## **MTC ALABAMA SUBDIVISION**

APPLICATION NUMBER 2 DATE February 1, 2018

REQUEST Subdivision

# DETAIL SITE PLAN

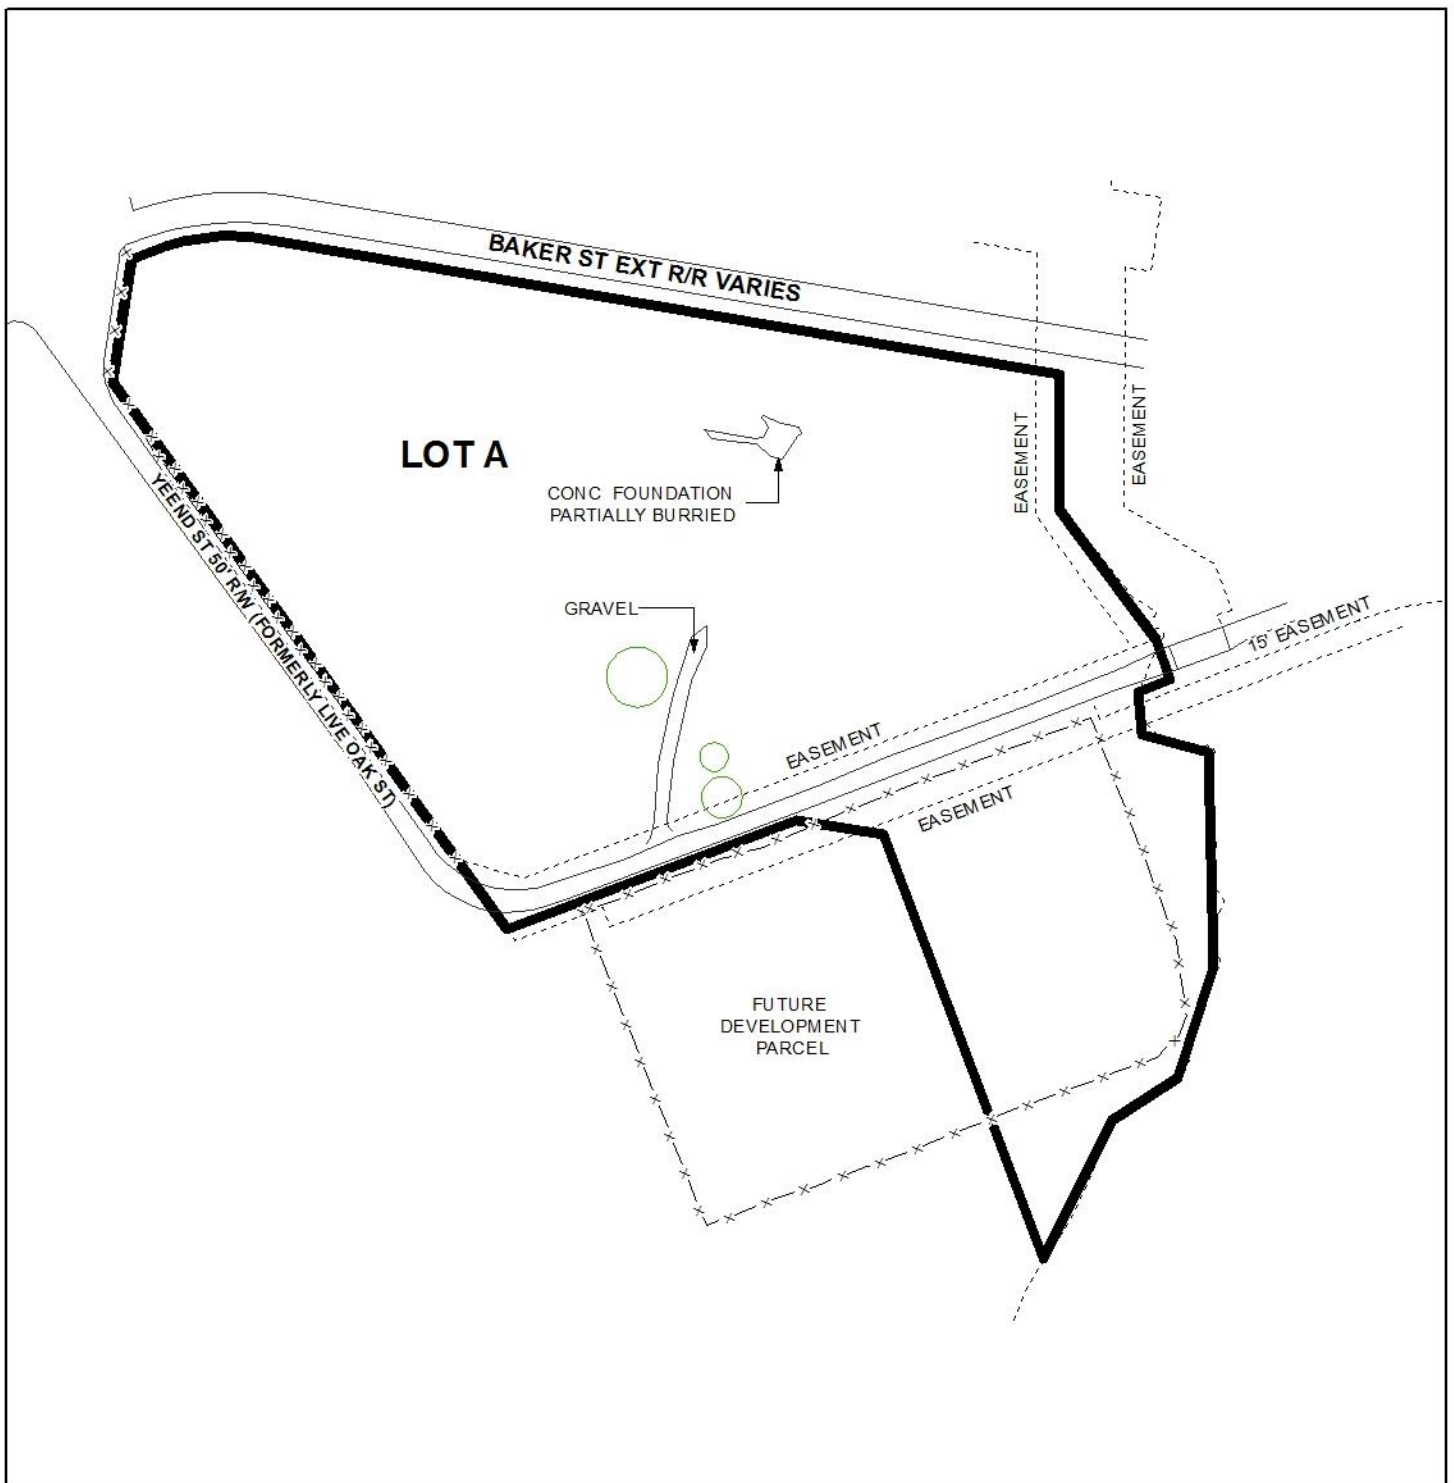
- A. Provide all of the required information on the SUBDIVISION PLAT (i.e. signature blocks, signatures, certification statements, written legal description, required notes, legend, scale, bearings and distances) that is required by the current Alabama State Board of Licensure for Professional Engineers and Land Surveyors.

- B. Label the Proposed LOT with an appropriate designator (i.e. LOT 1, LOT A)
- C. Add a vicinity map.
- D. Provide a written legal description.
- E. Show and label all of the curves listed in the curve table.

- F. Show and label the MFFE (Minimum Finished Floor Elevation) on each lot that contains an AE, V, or X (shaded) flood zone designation.
- G. Show and label each and every Right-Of-Way and easement.

- H. Provide and label the monument set or found at each subdivision corner.
- I. Add a signature block for the Owner, Notary Public, Planning Commission, Traffic Engineer, and City Engineer.

- J. Provide the Owner's (notarized), Planning Commission, and Traffic Engineering signatures.
- K. The proposed CITY OF MOBILE DRAINAGE EASEMENT will need to be revised. The area along the east property line is receiving drainage from a public street and will require a PUBLIC (Dedicated to the City of Mobile) drainage easement; the width and alignment of the easement shall be coordinated with, and approved by, the City Engineer prior to submitting the Plat for signatures.

- L. National Wetlands Inventory (NWI) mapping, as shown on City of Mobile GIS information, indicates that there is potential for wetlands within the property or properties shown on this plat. Show and label the delineated wetlands, or provide a note that the wetlands shown on this plat are scaled from the NWI data and have not been delineated.

The proposed lot meets the minimum size requirements of the Subdivision Regulations. However, no lot size is provided on the plat. The plat should be revised to label the lot with its size in both square feet and acres, after any required dedications, or a table should be furnished on the Final Plat providing the same information. The plat should be revised to illustrate a 25' minimum building setback line along all public street frontages.

Numerous easements, utilities rights-of-way and agreements to allow utilities are indicated on the plat; therefore, a note should be required on the Final Plat stating that no structures may be constructed or placed within any easements, utilities rights-of-way or utilities agreements.

- 1) dedication to provide 25' corner radii at the intersection of Baker Street and South Lawrence Street, and at the intersection of South Lawrence Street and Yeend Street;

- 2) placement of a note on the Final Plat stating that the lot is denied access to South Lawrence Street, and limited to two curb cuts each to Yeend Street and Baker Street, with the size, location and design to be approved by Traffic Engineering and conform to AASHTO standards;

- 3) revision of the plat to label the lot with its size in both square feet and acres, after any required dedications, or the furnishing of a table on the Final Plat providing the same information;

- 4) revision of the plat to illustrate a 25' minimum building setback line along all public street frontages;
- 5) placement of a note on the Final Plat stating that no structures may be constructed or placed within any easements, utilities rights-of-way or utilities agreements;
